CLUB BOCA

Issue: Vertical accessibility to a mezzanine, as required by Section 553.509, Florida Statutes.

REQUEST FOR WAIVER FROM ACCESSIBILITY REQUIREMENTS
CHAPTER 553, PART V, FLORIDA STATUTES

**PLAN REVIEW COMMENTS
Second Review**

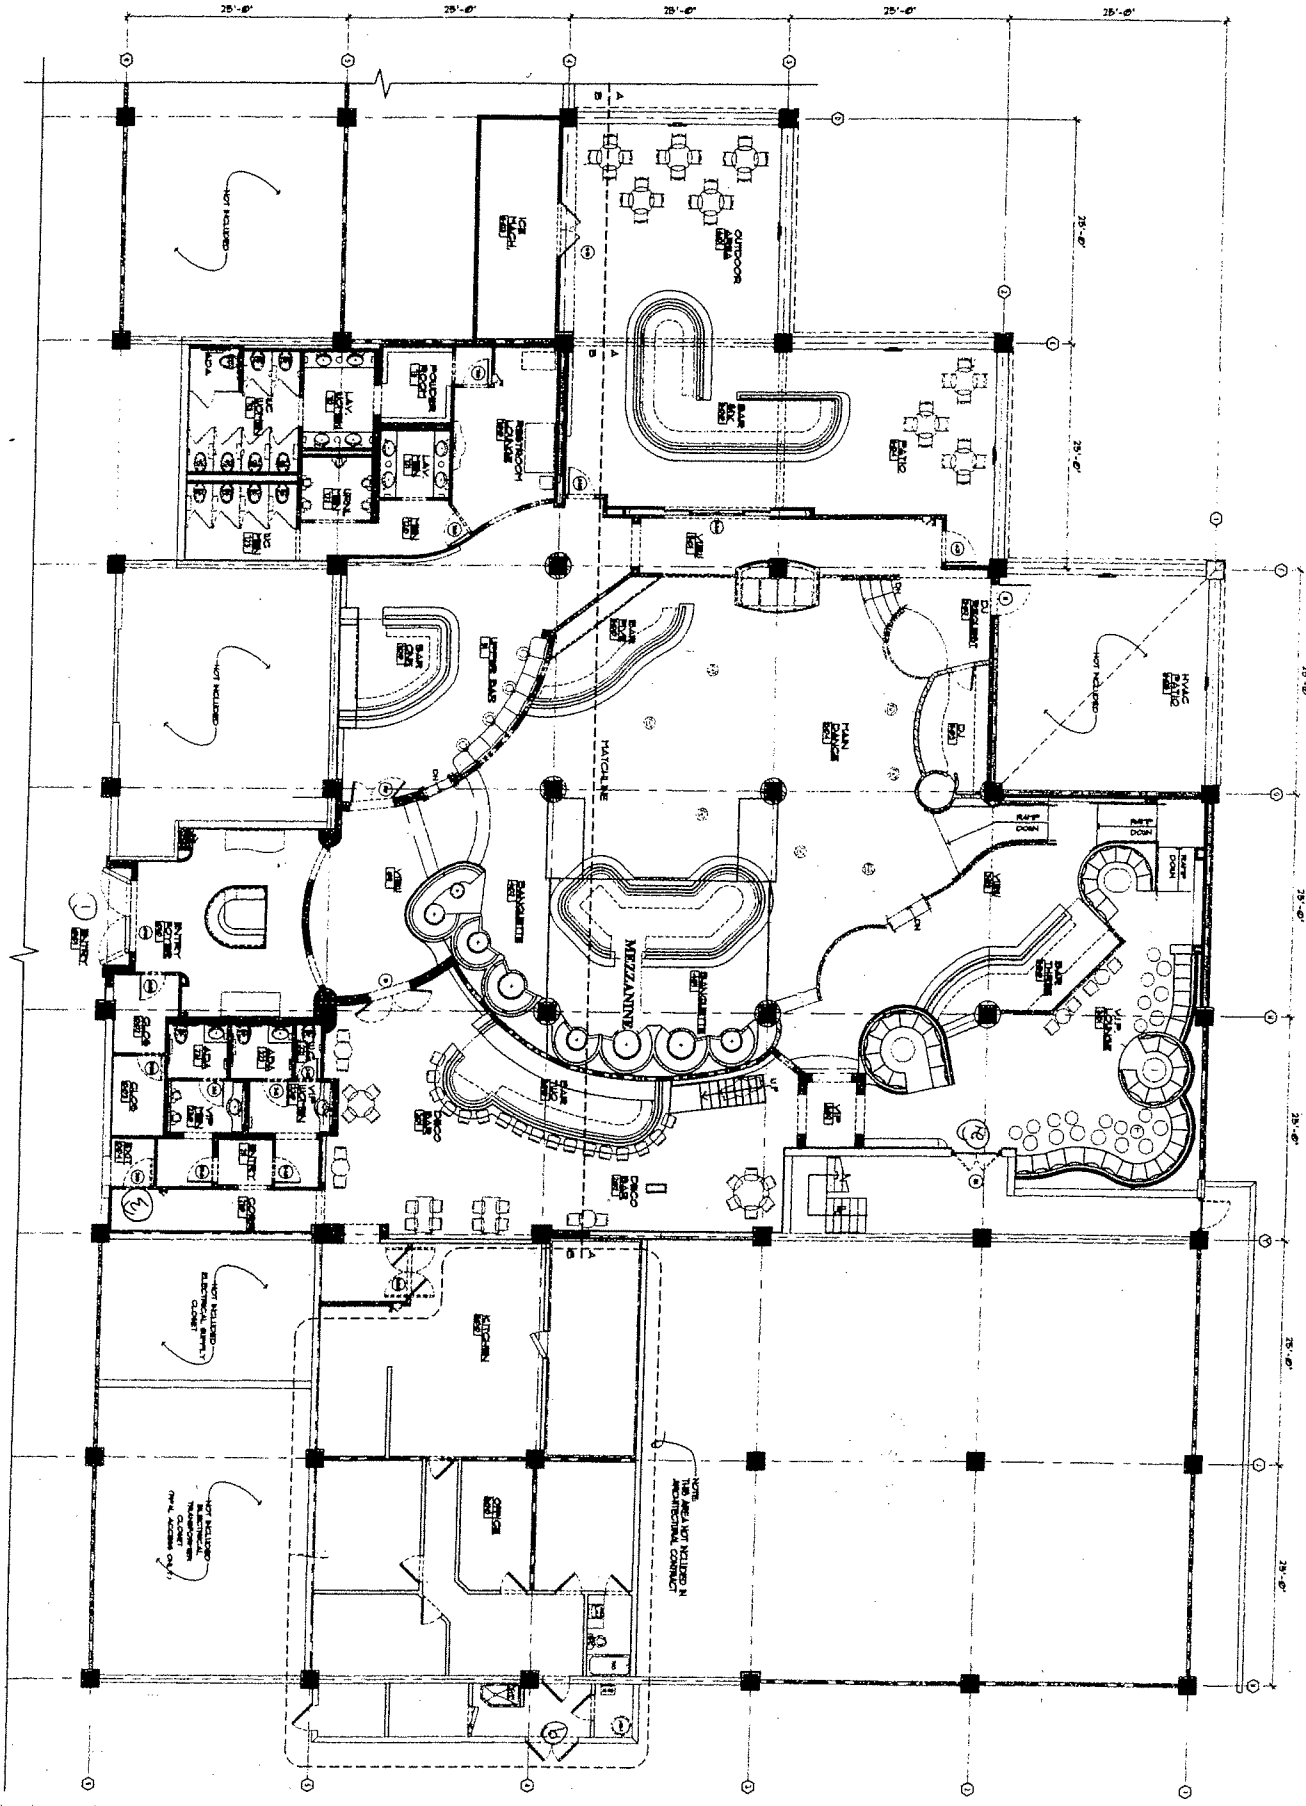
- Mr. Nevins, please be advised that the Building Dept. did not agree with your engineer's argument with respect to the exemption to the vertical accessibility requirement to the "mezzanine." The exception he sites apply to "performing area". We do not consider the mezzanine a performing area, nor do we agree that it is "technically infeasible" to comply. We recommend that you obtain a "waiver" from the Dpt. of Community Affairs. The required paperwork may be found in the back of Chap. 11. Note that the request for waiver needs to be reviewed by the Building Official before submitting to DCA.
- The engineer states that the type of construction is "Type I and Type II." It can't be both. Select one.
